**SUBJECT:** **NEW VEHICLE DEMONSTRATION / DELIVERY HOLD - Compliance Recall 17C05**  
Certain 2017 Model Year Edge Vehicles Equipped with Panoramic Vista Roof  
Missing Front Windshield Header Welds

**NEW VEHICLE DEMONSTRATION / DELIVERY HOLD - Compliance Recall 17C05**

## CERTAIN 2017 MODEL YEAR EDGE VEHICLES WITH PANORAMIC VISTA ROOF — MISSING FRONT WINDSHIELD HEADER WELDS

FIGURE 1

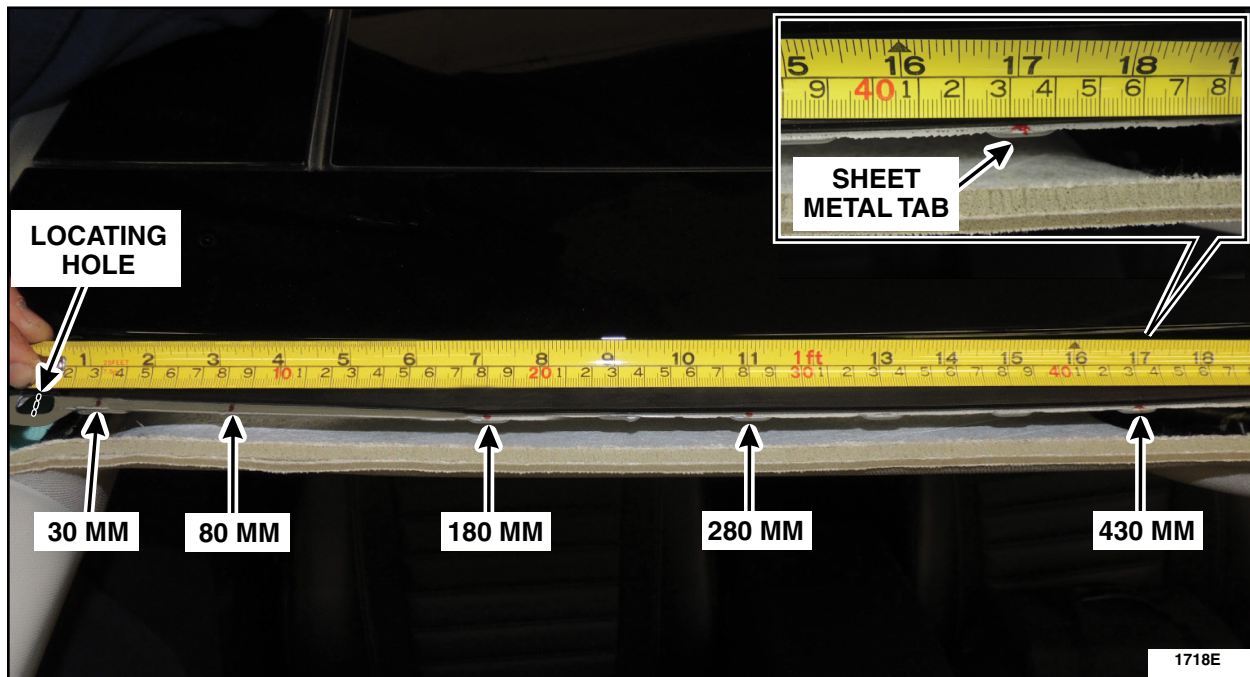
2. Using a metric tape measure or rule, measure the distance from the center of the locating holes at both the left and right top corners of the windshield opening inward, and mark the body sheet metal tabs at 30 mm, 80 mm, 180 mm, 280 mm, and 430 mm. See Figure 1.

**FIGURE 4**

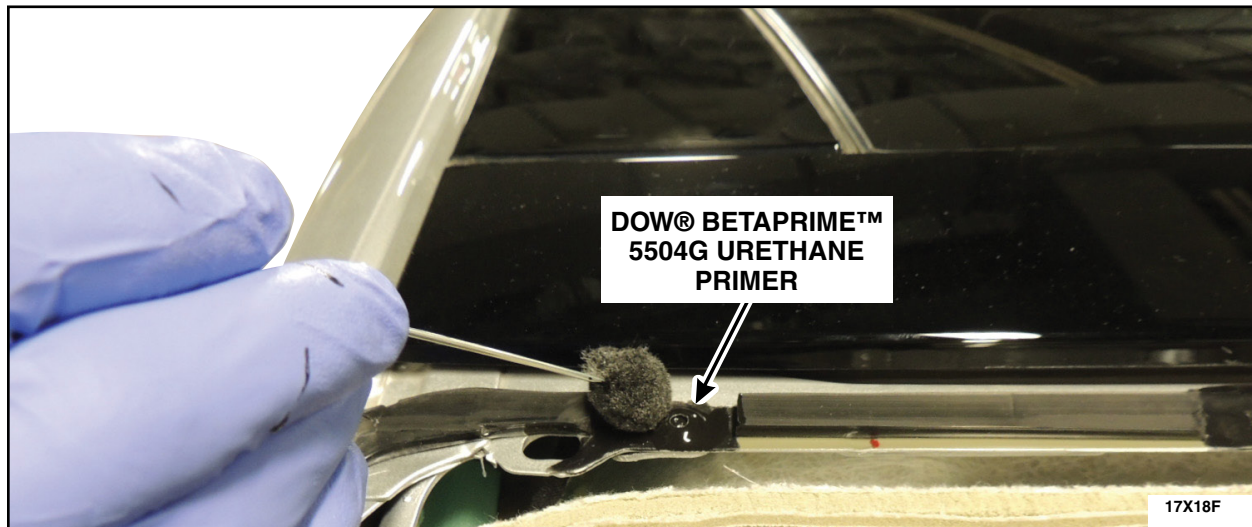
10. Reapply Dow® BETAPRIME™ 5504G urethane primer, completely covering the rivet heads and the area where primer was previously applied. See Figure 4.
